RE: Independent Design Consultants Report

# DESIGN CONSULTANT REPORT

# 76 PLACE *at Market East*

Lane Closure Details. Image source: March 2024 CDR Submission

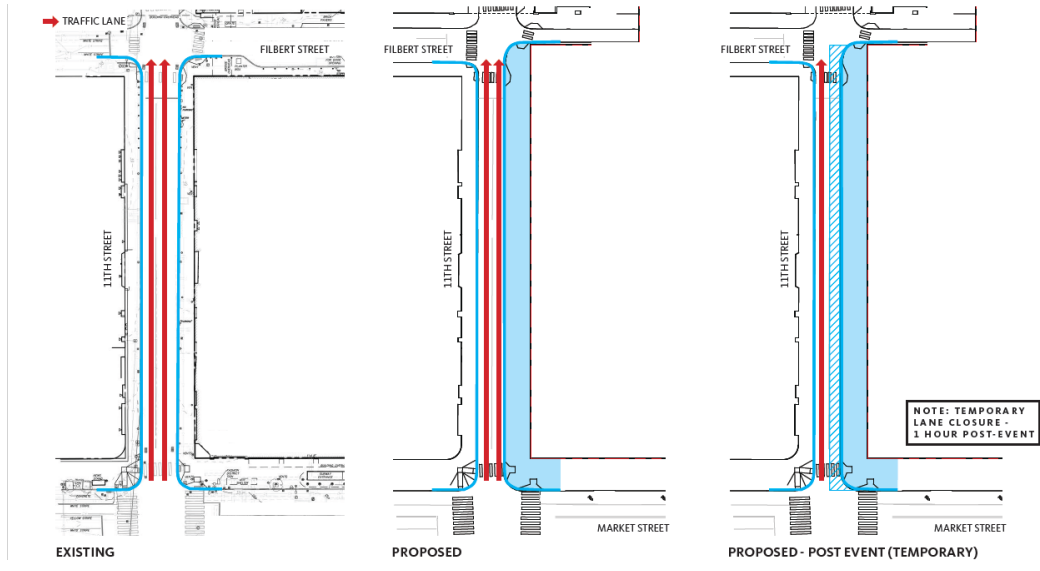
**17. Temporary Lane Closures:** Submission states: "NOTE: Temporary Lane Closure - 1 hour post-event." It is not clear what the purpose of the post-event lane closure is. The way in which the lane closure is designed is also in question. Is this through temporary measures (event day safety cones or flex posts) or more permanent design measures such as paving options? More information is needed regarding the design aspects of the proposed closures.

Proposed Ground Floor Plan Image source: March 2024 CDR Submission

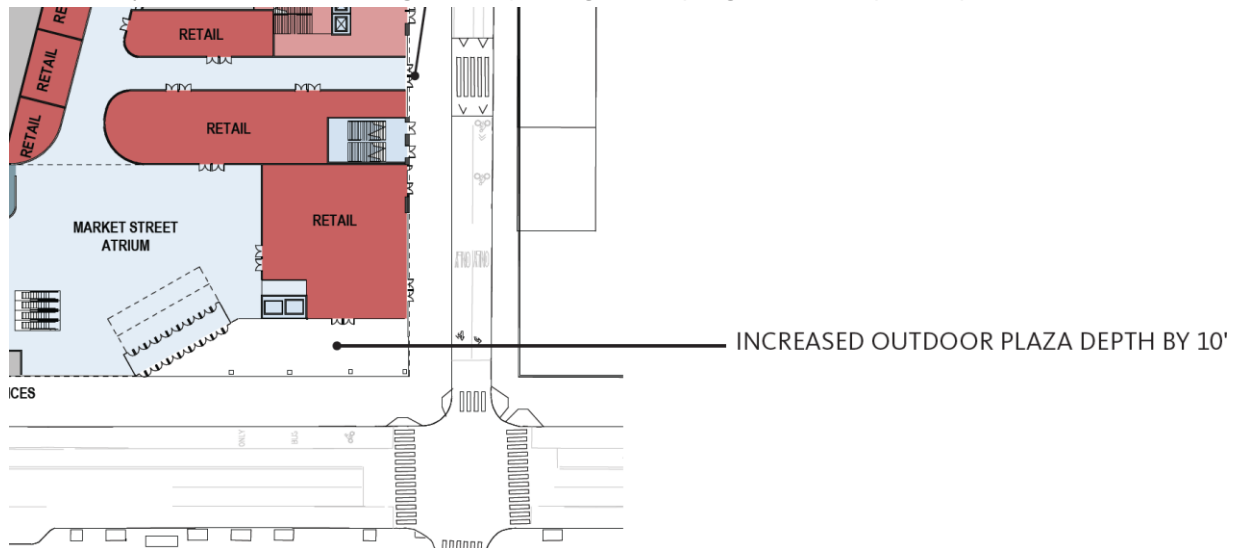
- 8. Deactivated Interior Frontage:** Area designated “Arena Ops” is still an unfortunately deactivated frontage facing a major point of entry for the arena (from 10<sup>th</sup> Street).

Proposed Ground Floor Plan Image source: March 2024 CDR Submission

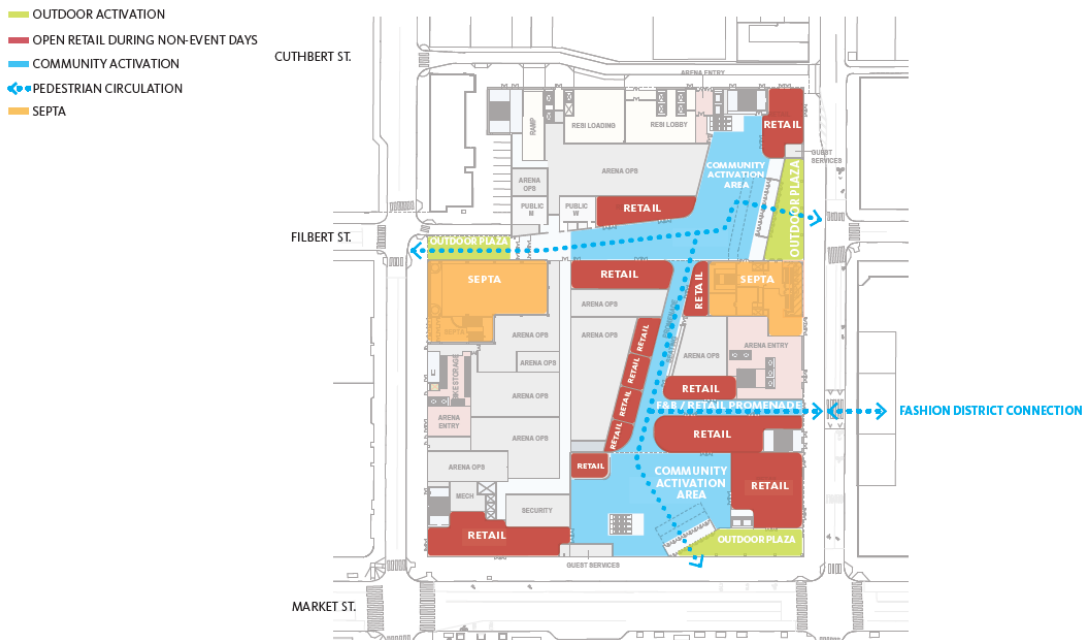
- 9. Arrival Zone:** Increased square footage for entry spaces is appreciated, although the primary (10<sup>th</sup> and Market Streets) and secondary entrances (11<sup>th</sup> and Filbert Streets and 10<sup>th</sup> and Filbert Streets) still fall short of being civically designed or programmable public plazas.

Proposed Ground Floor Plan Image source: March 2024 CDR Submission

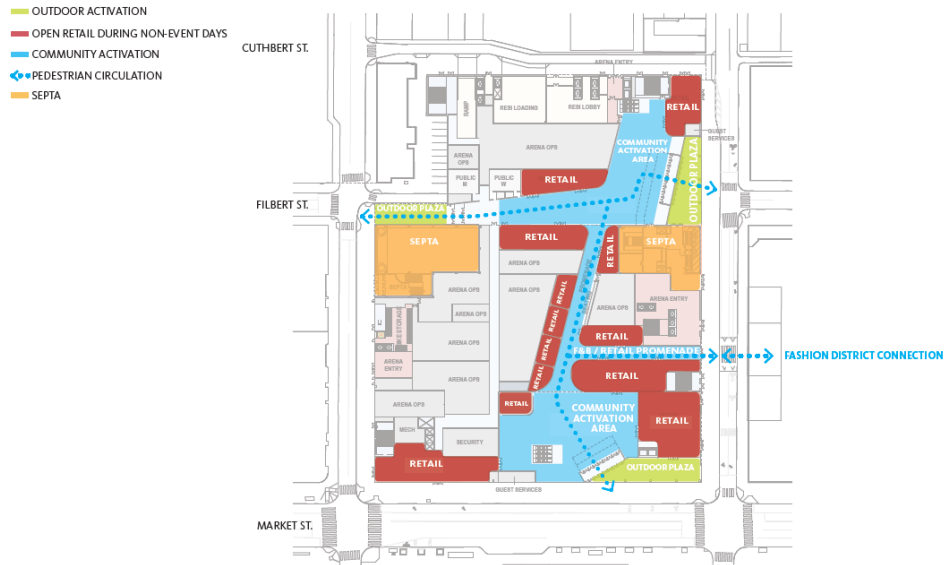
- 3. Community Activation:** While the Review Team appreciates the second submission designating the northern lobby as a "community activation area", our suspicion is that it will be less active than the similarly labeled space on Market Street. More information is required regarding how these two functions (residential tower and its associated elements and the arena) work together (if at all).
